PD Modification Application: PRS 25-0918
Zoning Hearing Master Date: NA
BOCC Land Use Meeting Date: September 9, 2025

1.0 APPLICATION SUMMARY

Applicant: JPMorgan Chase Bank, National Association
FLU Category: UMU-20 (University Mixed-Use)
Service Area: Urban
Site Acreage: 3.44 Acres
Community Plan Area: East Lake/Orient Park
Overlay: None

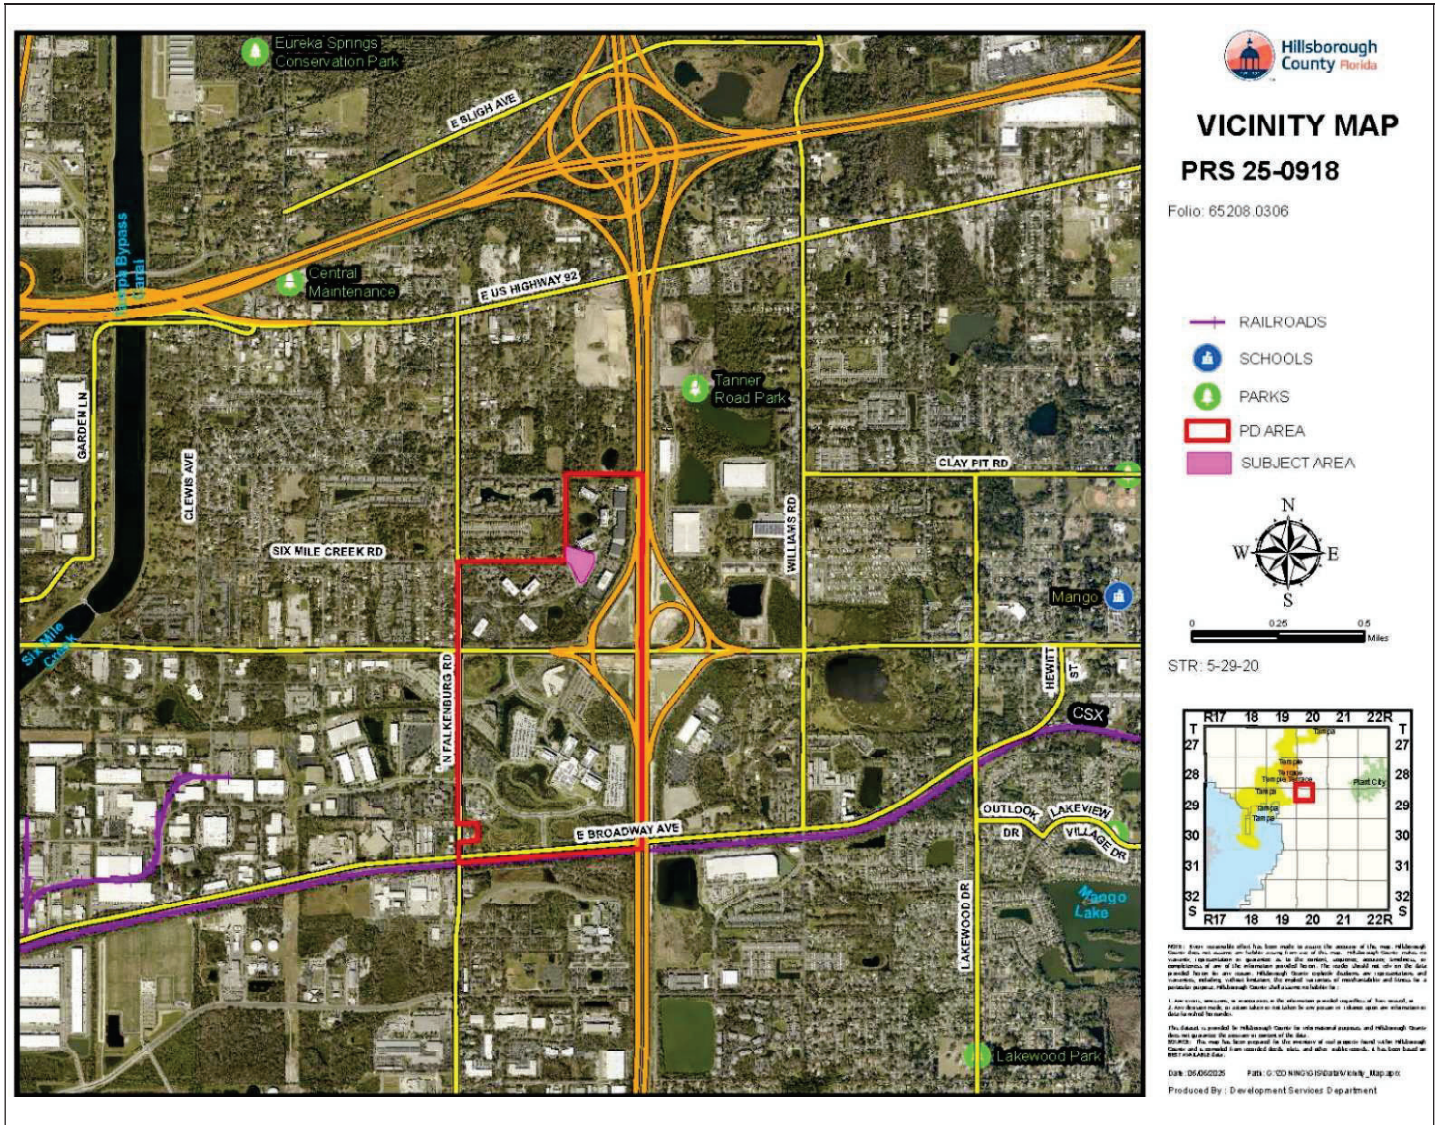
Existing Approvals	Proposed Modifications
No access connection from Pod 10 to folio 65140.0000 to the west. Pod 10 access to Bryan Road. No emergency access for Pod 10.	POD 10: add a shared access connection with the property having folio number 65140.0000, add a connection to Highland Manor Drive, and revise the plan to show an existing emergency access to Bryan Road.
